# DCAF Bulletin

No. 95-04

Subject: MASONRY BOND BEAMS

DETAIL NO. 6.2

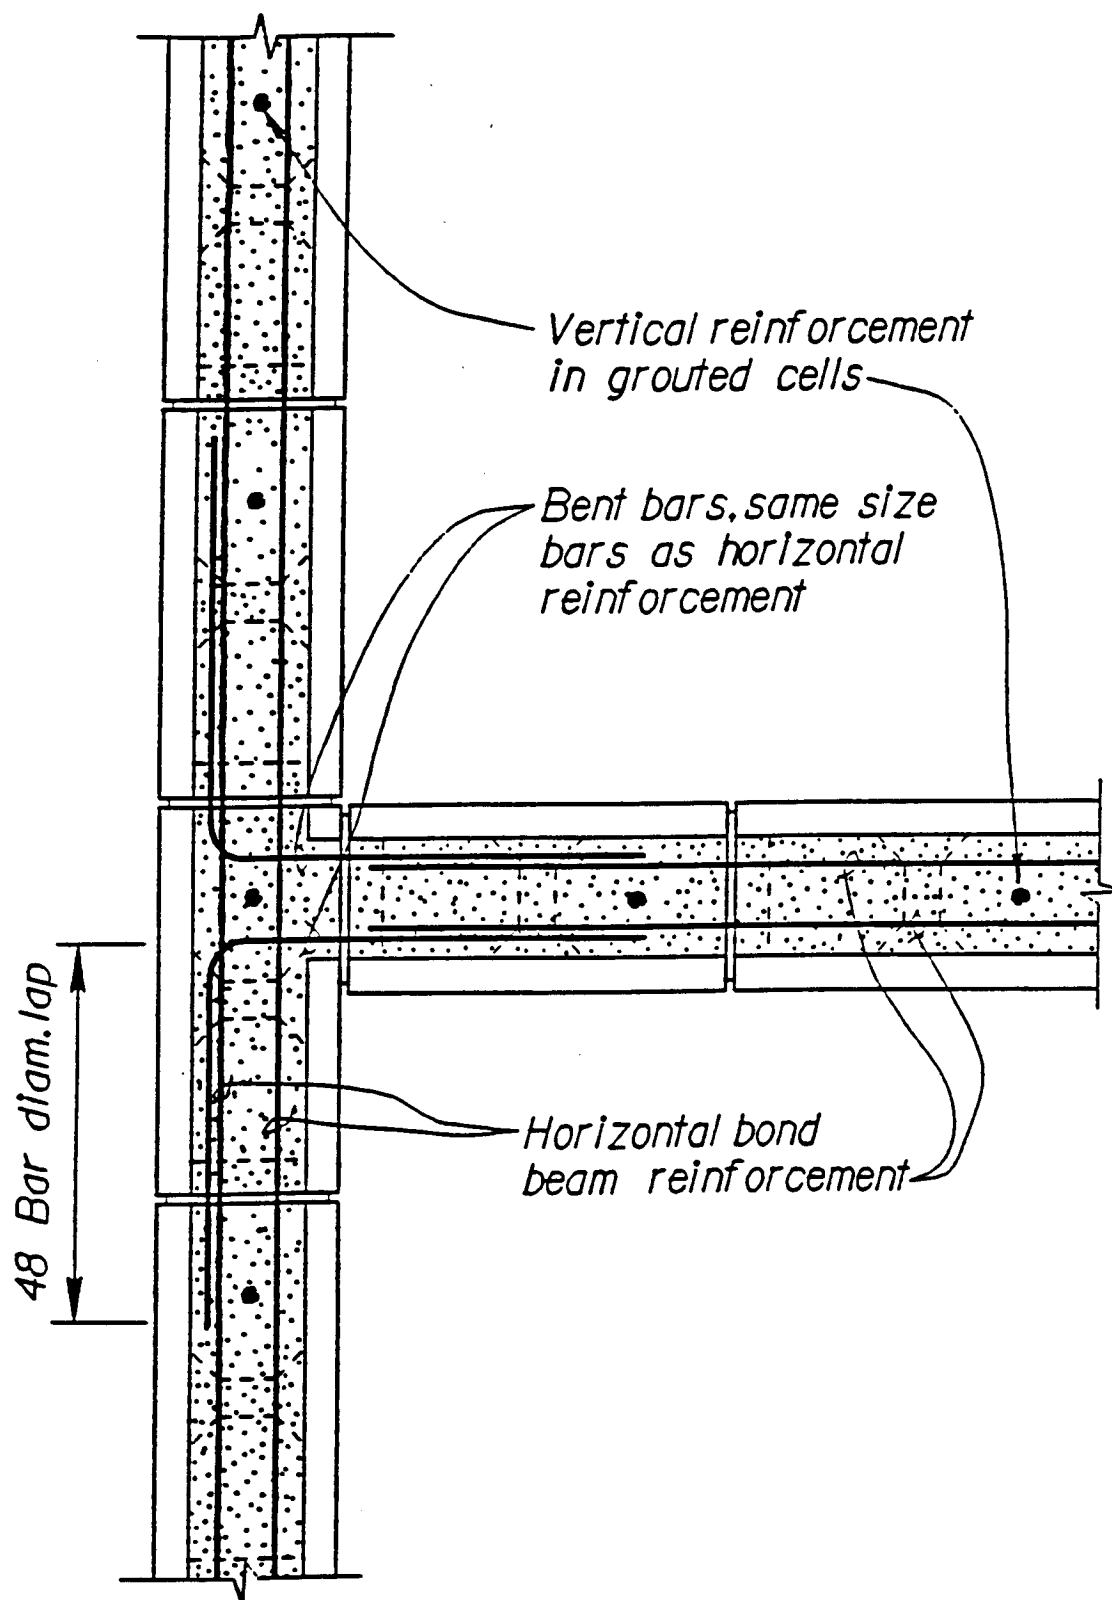
2. One of the most common deficiencies noted on recent Design-Construction Evaluations(DCE) is the lack of continuity at the corners and wall intersections. In order to be structurally effective, bond beams must be continuous at the corner. Also, intermediate wall intersections should have continuous reinforcement unless a control joint is located there.

3. Standard details of bond beam intersections are being omitted from the contract drawings. The omission of these details leaves the design of these intersections to the contractor. This usually results in a discontinuity of the bond beam at each corner and wall intersection. Design of this feature should not be left to the contractor's discretion. It is too important. The continuity, or lack thereof of the bond beams, influences the capacity of the wall to resist lateral loading. This design must be reflected on the contract drawings. A book of standard details entitled "Masonry Details", Detail No 000-90-04, December 1992, is available from Huntsville Division, CEHND-ED-EF-1. Design Branch in each district should obtain a copy of this publication, and should make sure that the A-E design firm is given a copy of pertinent details for inclusion in the contract drawings. CEGS 04200 has the following instruction:

"Details will be shown on the drawings which illustrate corners and intersections of structural bond beam reinforcement ....". BCOE reviewers should insure that these details are included in the contract so the contractor is not required to assume a design. (See enclosure 1&2).
